GLOBAL SAFETY FIELD INVESTIGATIONS
DCS5422
URGENT - DISTRIBUTE IMMEDIATELY

Subject: A202302140-01 - Service Update
Engine Oil Pressure Sensor Performance Error
Revised Part, Warranty and Service Procedure sections

Models: 2020 Buick Encore GX
2021 Chevrolet Trailblazer
Equipped with 1.2L Turbo Engine (RPO LIH)

A202302140 Engine Oil Pressure Sensor Performance Error

5584378

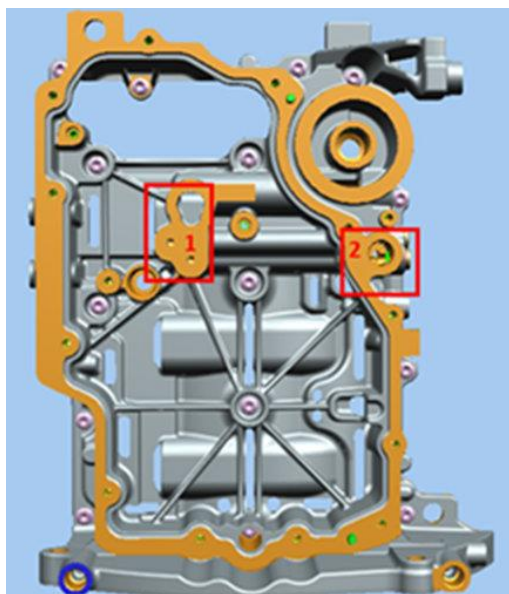
4. Raise the engine speed to 2,000 rpm for 30 seconds.
5. Rev up the engine rpm to 4,000 rpm limit and hold for 15 seconds.
6. Release the acceleration pedal to go down rpm to idle and wait for 15 seconds.

Important: One test cycle is from steps 4 to 6.

7. Repeat the test cycle (Steps 4-6) ten times.
8. Check DTC Display Tab for trouble codes P0521, P06DE, P06DD. Exit Engine Mechanical Data screen to save session log.
9. If any of these DTCs set: P0521, P06DE, P06DD, skip to Step 15.
 - If P0521, P06DE, P06DD are not present, proceed to Step 10.
10. Turn off the engine.
